**Notice of Intention  
To Commence Large Mining Operations**

**US Oil Sands (Utah) Inc.  
PR Spring Mine  
M0470090**

May 2009

Figure 4b  
Earth Energy Resources Inc. - PR Spring Oil Sand Mine  
Transverse Mine Section W2-E2 Rev.2

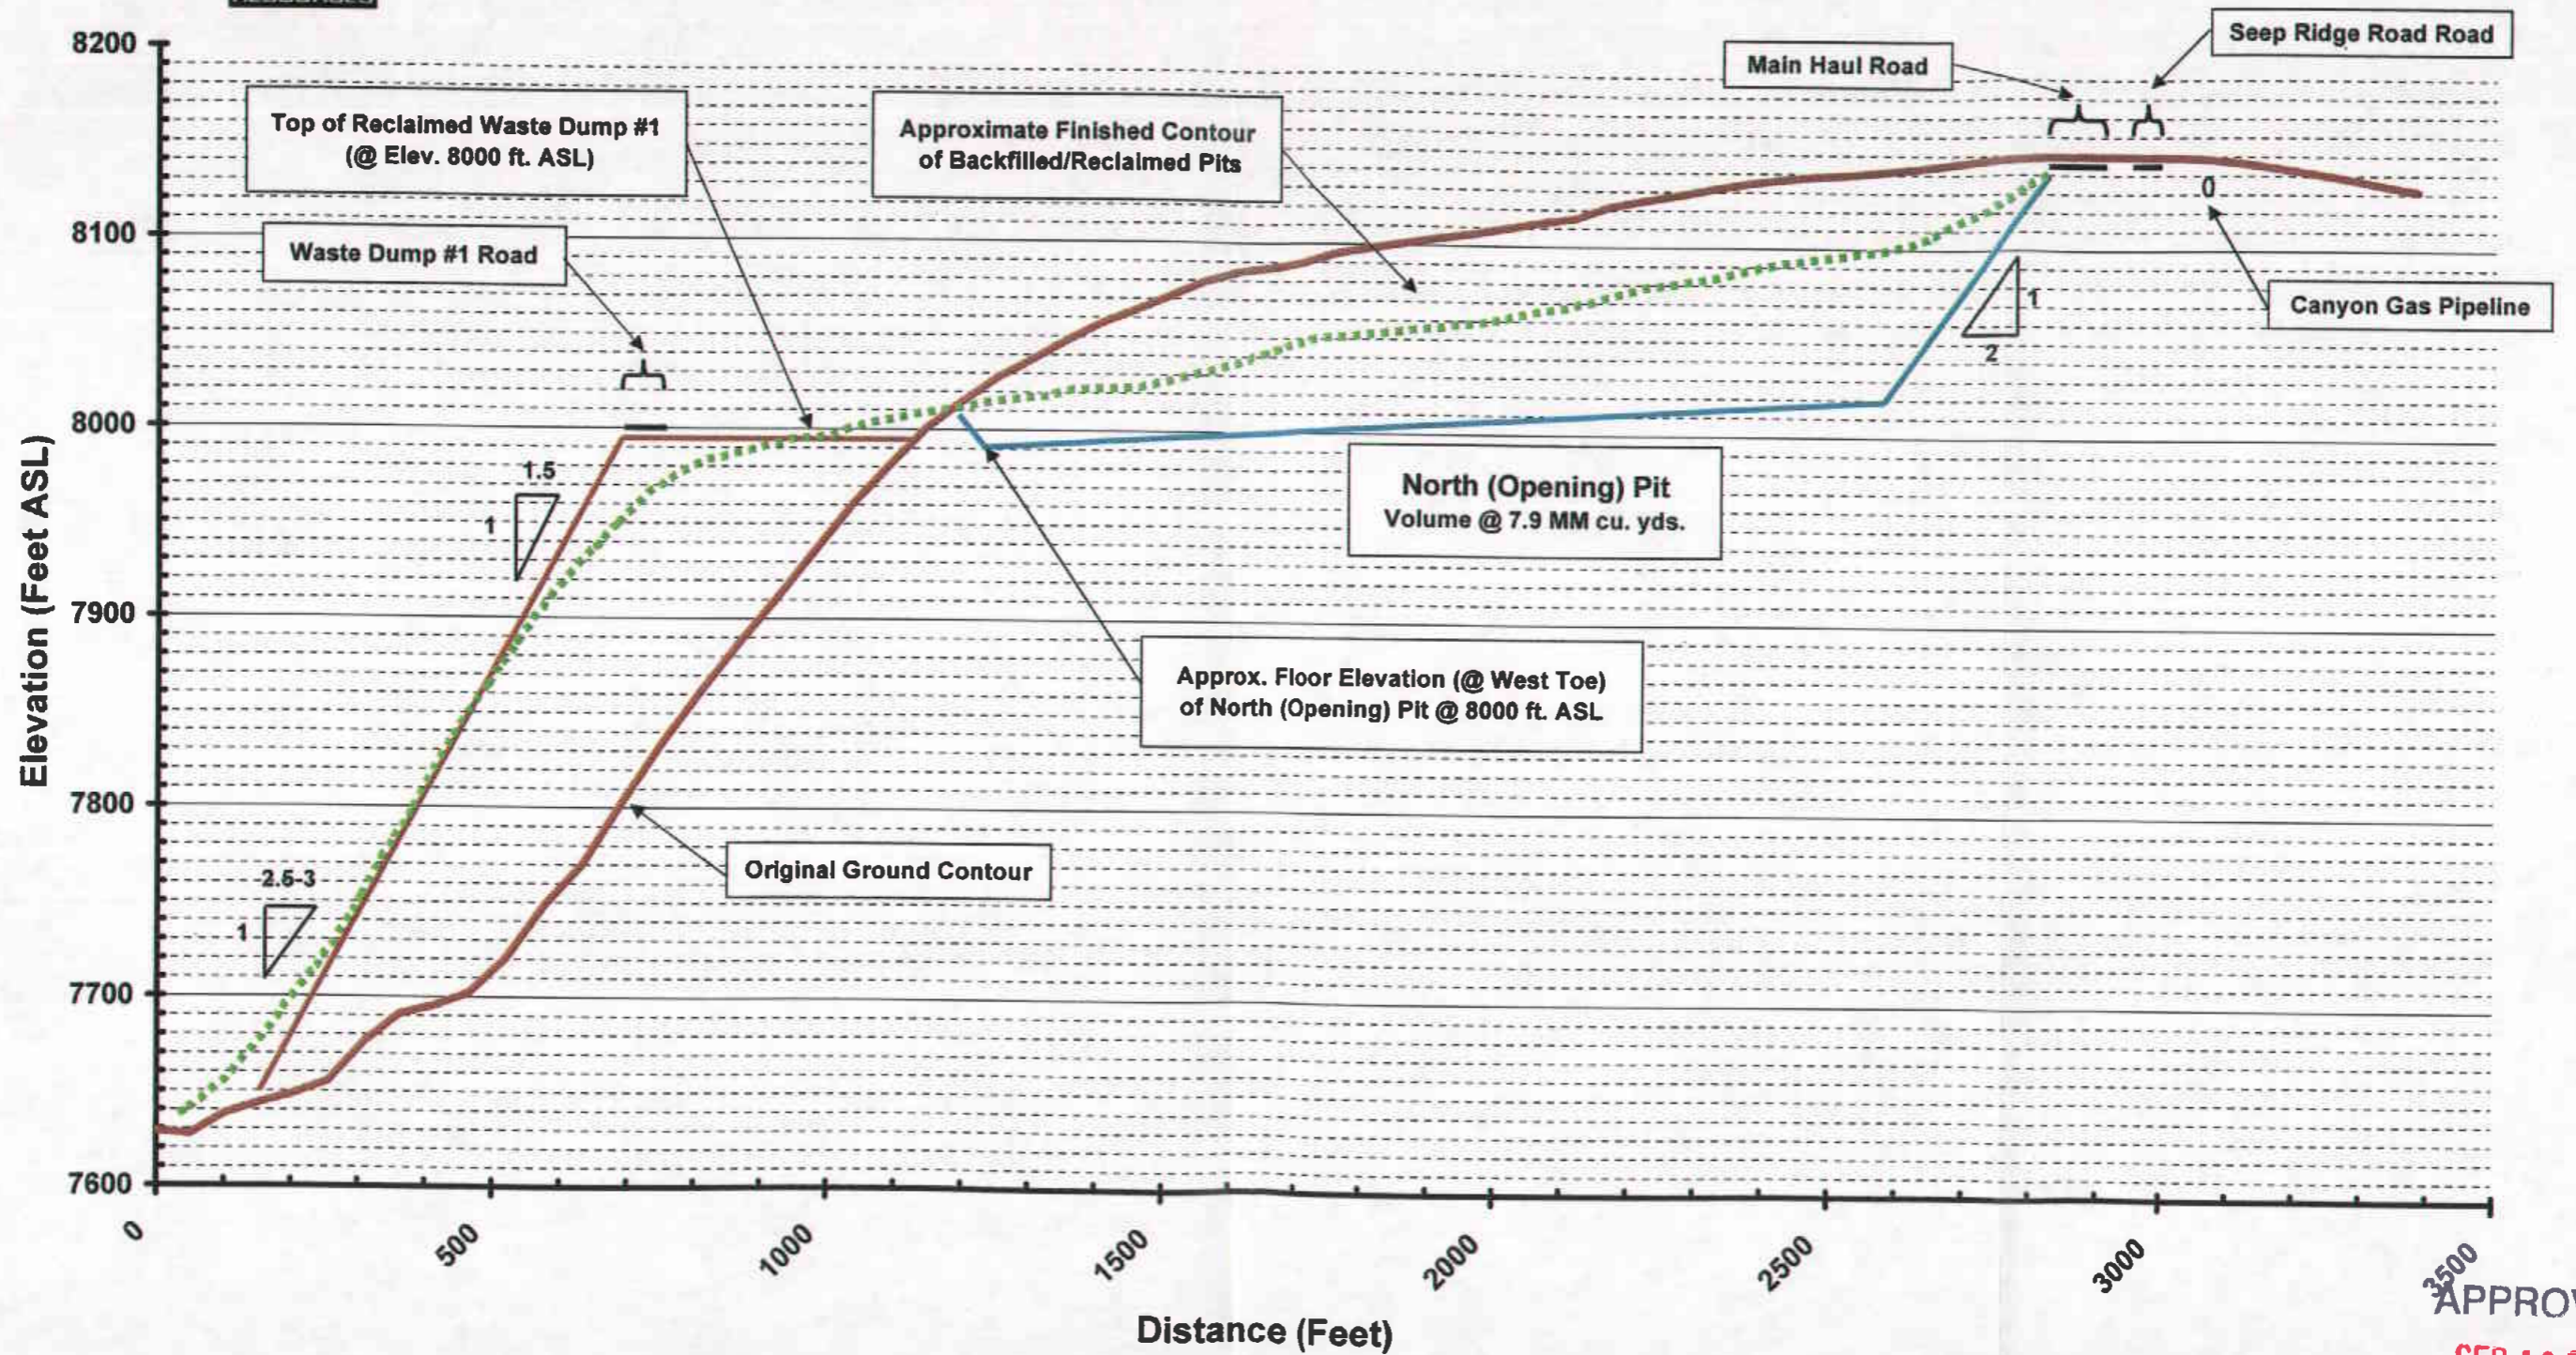
Based upon our phone conversation this morning, I am attaching Figure 1 for the Earth Energy PR Spring NOI - which was unfortunately omitted in the May 9, 2008 submittal; and Figure 4b - which was revised to show the accurate horizontal to vertical alignment of the reclaimed waste dump slope at 1.5 H:1V. Please accept these Figures for the May 9, 2008 response to the Initial Review of NOI to Commence Large Mining Operations, Earth Energy Resources, PR Spring Mine (M/047/0090).
